## **Appendix G – NWWM Correspondence**

**From:** Kirsten Huizer  
**Sent:** 05 April 2017 14:27  
**To:** Paul Bayliss  
**Cc:** John Pattinson; Heather Stone  
**Subject:** RE: Land to the West of pearl Lane, Stourport

I have had a quick look at the submitted FRA (Rev 0). You might notice that I was consulted for historic flood data, but unfortunately the consultant was not available to meet me on site before finalising this first version. Would we have met on site then hopefully the approximate location of the culverted watercourse (mentioned in 2.14 and shown in Appendix C) would be crossing the site west to east, rather than north to south!

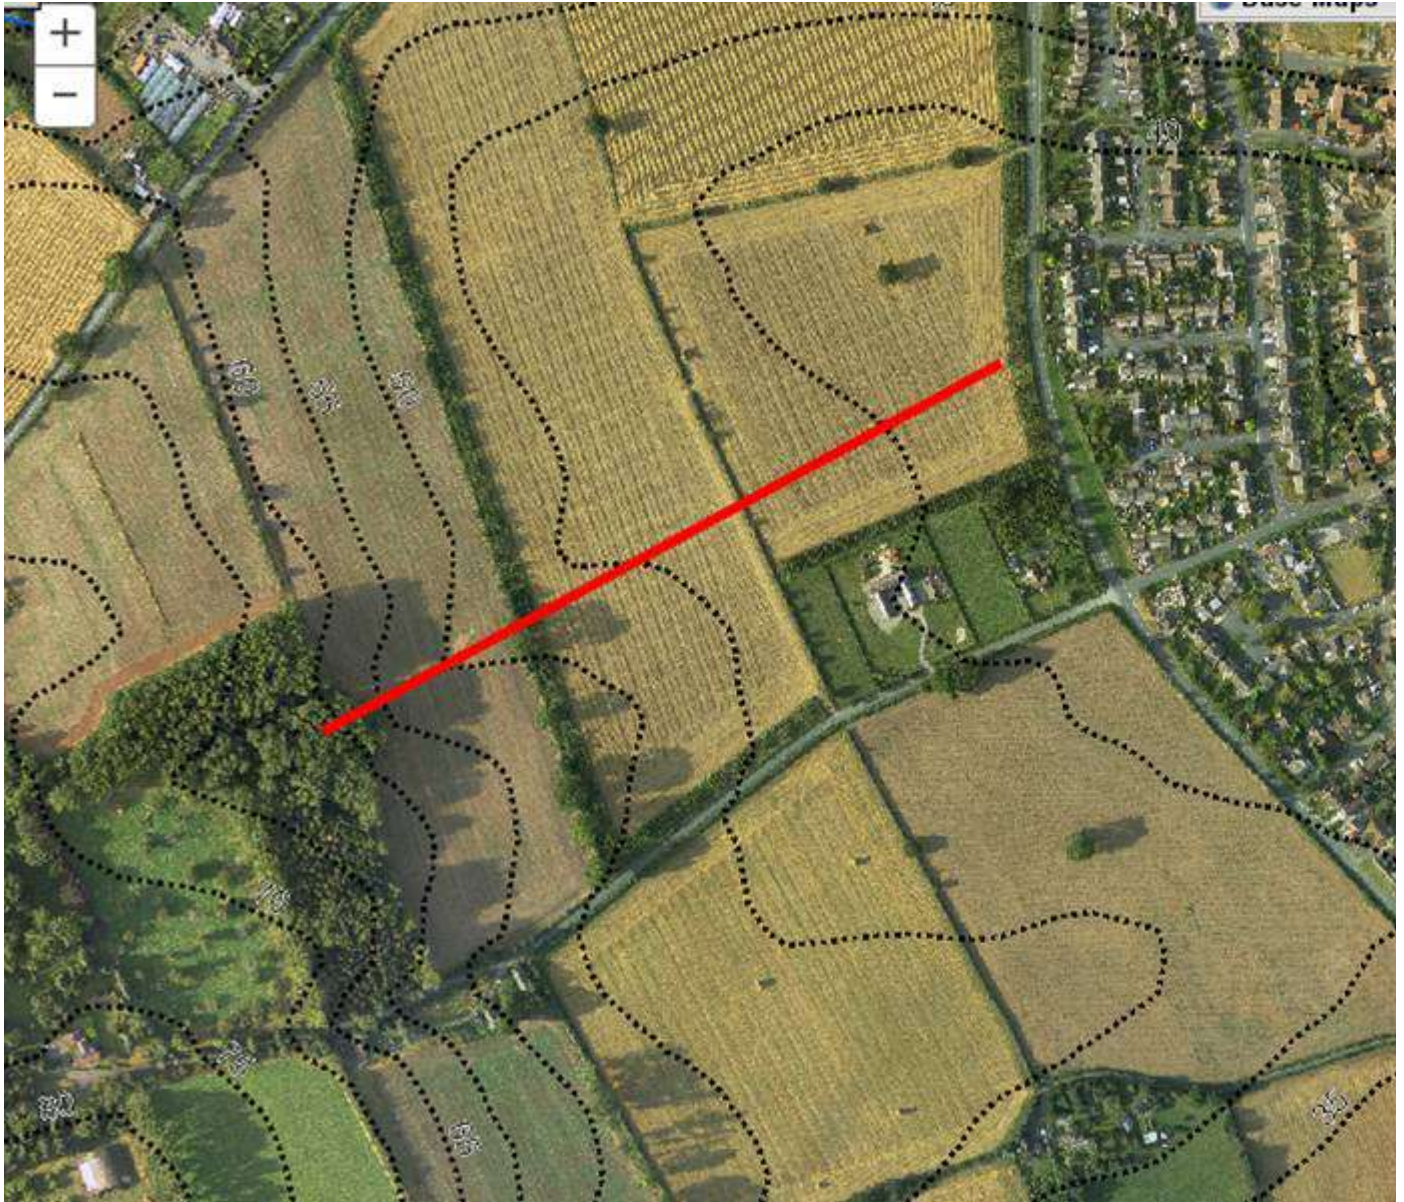
- 2.10 does mention Burnthorne Brook as a nearby watercourse, but not the culverted watercourse that actually crosses the site (I've drawn a line where I think the watercourse can roughly be found. Admittedly it is only a small asset but as I understand that it does take spring water from the top of the hill I do class it as a watercourse. Old maps show a pond here. This is outside our district and I have not been there to confirm whether the pond still exists. Further investigation would be required!). The culverted watercourse is known to me as the Dunley Brook

- 2.14 as set out above, Dunley Brook discharges through the site from west to east, not north to south, and it leaves the site at Pearl Lane, not in between the residential properties to the south of the site.

- Appendix C, idem as above
- 4.6 states that STW may need to upgrade surface water sewers to alleviate any future flooding. This FRA does however not touch upon the fact that the STW surface water sewer falls out into a partly open partly culverted watercourse (discharging into Malvern Hills district at Malvern Edge Court) that is a private responsibility of riparian owners over which we have very limited powers. This watercourse already poses a flood risk and upsizing this system would be challenging to say the least. I think the FRA should be expanded to include this detail. Also it would be good to discuss with STW the status of their ongoing investigations into their network.
